**TOWN OF MOUNTAIN VILLAGE  
SPECIAL DESIGN REVIEW BOARD MEETING  
TUESDAY, MAY 31, 2022 10:00AM  
MOUNTAIN VILLAGE TOWN HALL  
455 MOUNTAIN VILLAGE BLVD, MOUNTAIN VILLAGE, COLORADO  
TO BE HELD HYBRID THROUGH ZOOM:**

**RE:** Staff Memo – Review and Recommendation to Town Council Regarding a Major Planned Unit Development Amendment to the Lot 109R Planned Unit Development, commonly called the Mountain Village Hotel PUD, by Tiara Telluride, LLC.

**APPLICATION OVERVIEW: Mixed Use Development inclusive of a hotel, condominiums, lodge units and employee housing on Lot 109R**

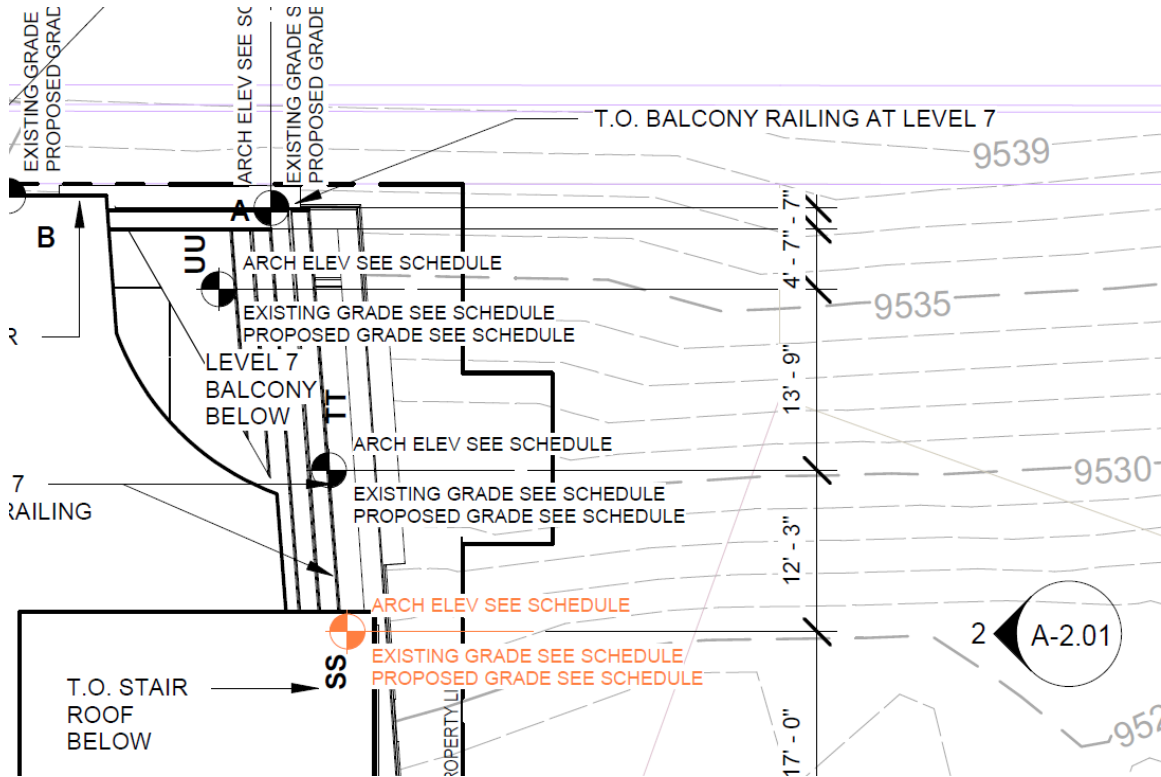
*There is one max height of 95' 0" shown at the main entry on the north elevation that was not counted per the direction of Town staff. The dimensions on this height are taken from the existing underpass connection. There is provision in the code whereby "If the Planning Division determines that there are minor irregularities in the natural grade, these areas shall not be used in determining compliance with the building height limitation set forth herein, and the surrounding typical natural grade shall be used."*

C2.4

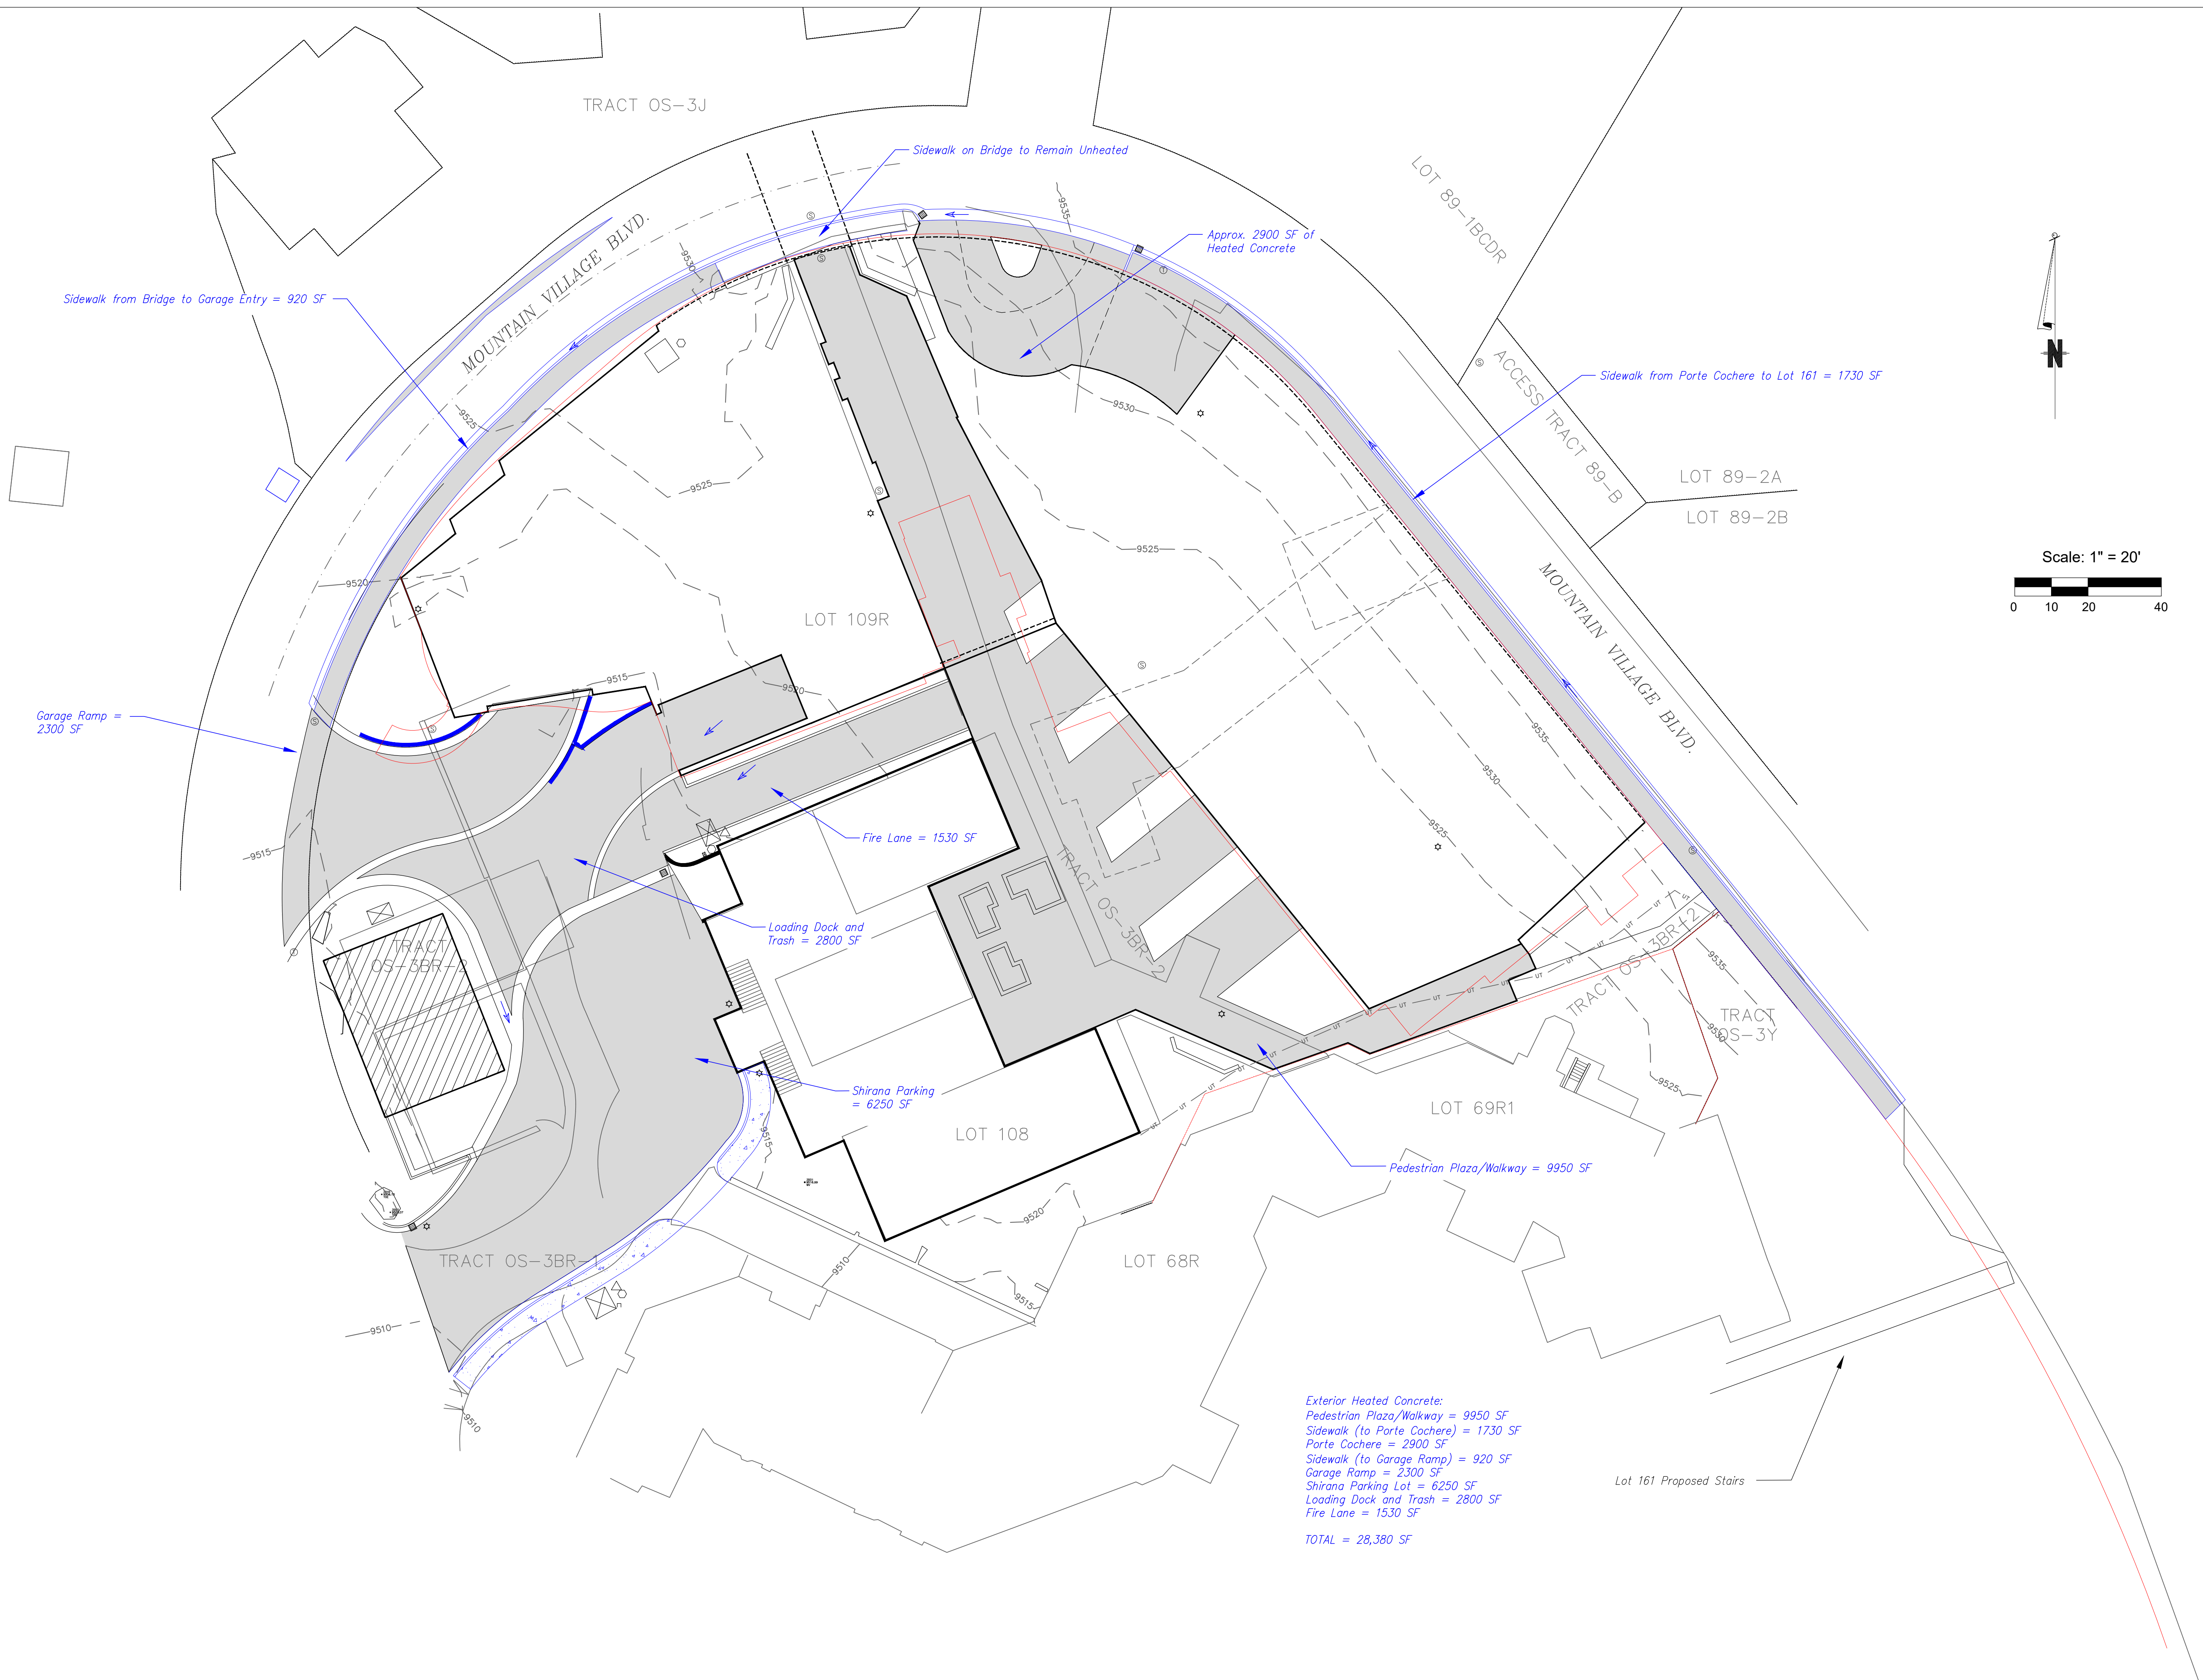
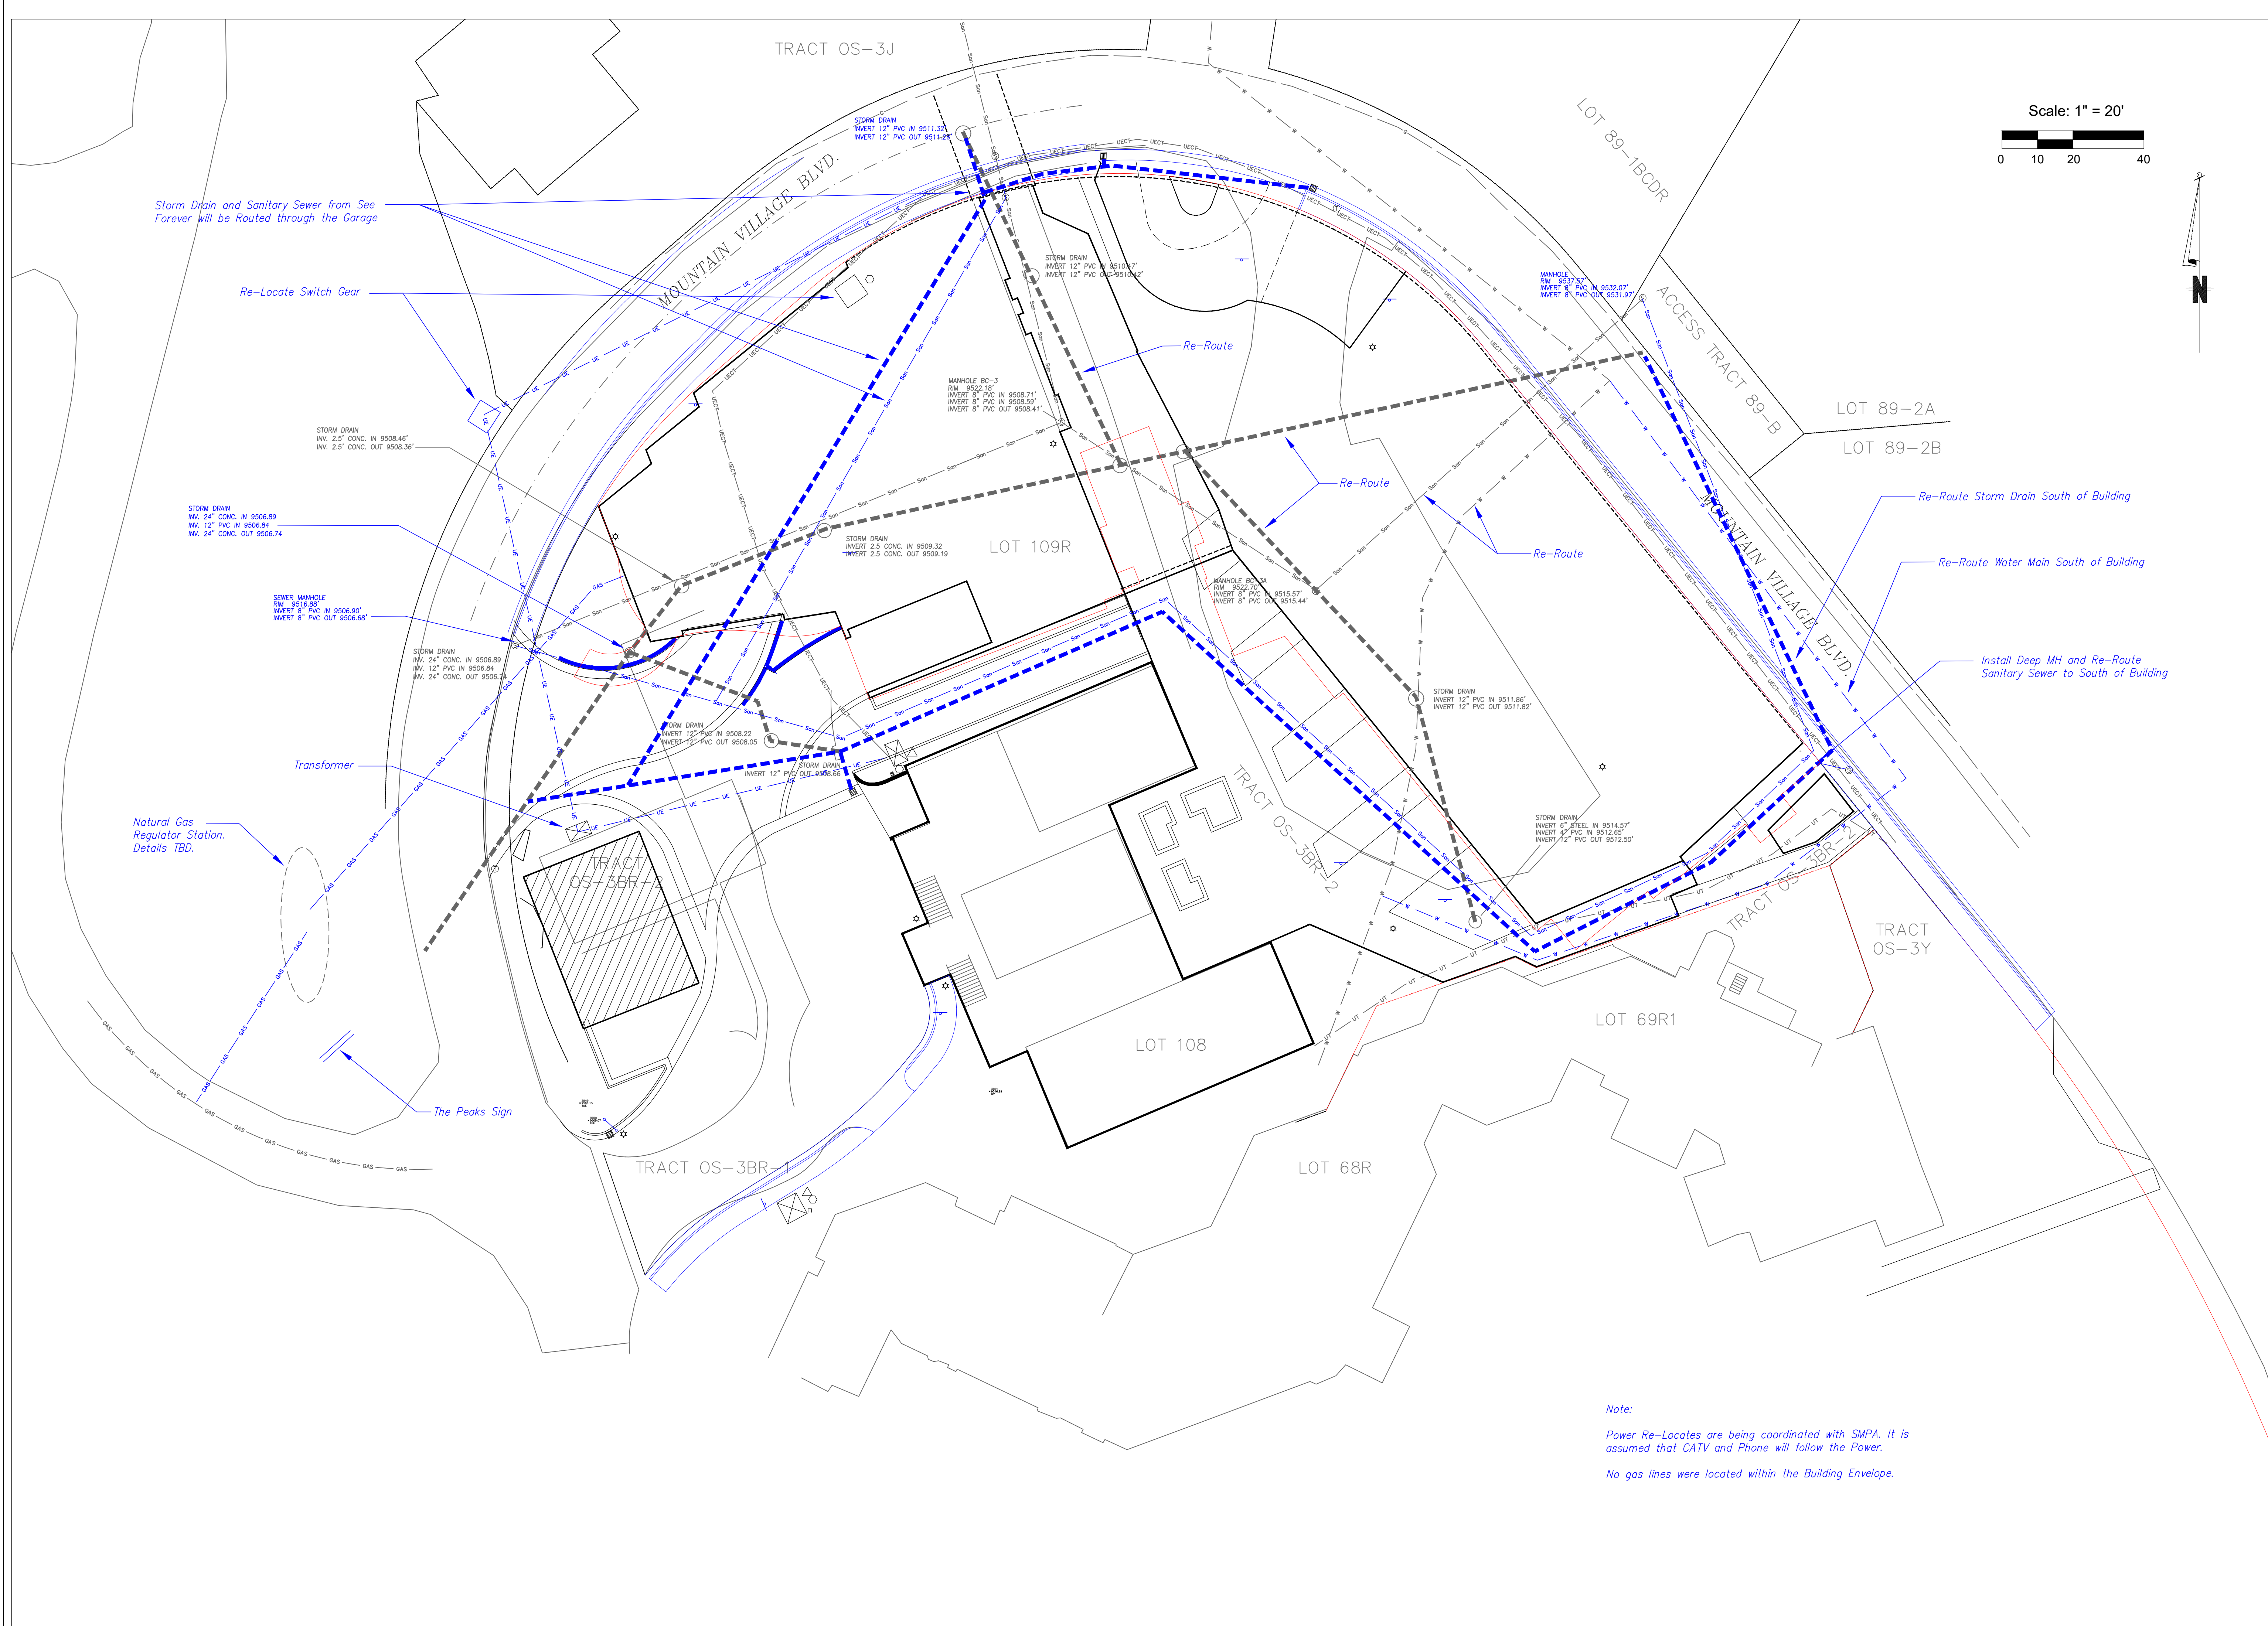
*Staff: The applicant has provided a snowmelt plan that indicates that the primary plaza will be snow melted. The pedestrian walkway through the building as well as the new proposed sidewalks along Mountain Village Boulevard will also be snow melted. The stairs to Mountain Village Boulevard on the SE side of the building could be problematic, however the applicant has represented that these will be steel grate so would not require melting. The prior PUD approval included snowmelt of the area of use over the towns OS-3BR-2 property (short term parking lot), however, the applicant illustrates revised plans using all of the OS-3BR-2 surface parking and driveway for their back of house use. Due to the expanded use the town is also requesting/requiring that all of this surface area be snowmelted. There is a small area to the south of the trash building and the sidewalk from the Shirana stairs to Mountain Village Boulevard which also needs to be snowmelted. The town recognizes that the applicant is providing significant snowmelt along with public improvements to create meaningful pedestrian pathways through and around the project that are safe and consistent with our CDC requirements in the Village Center.*
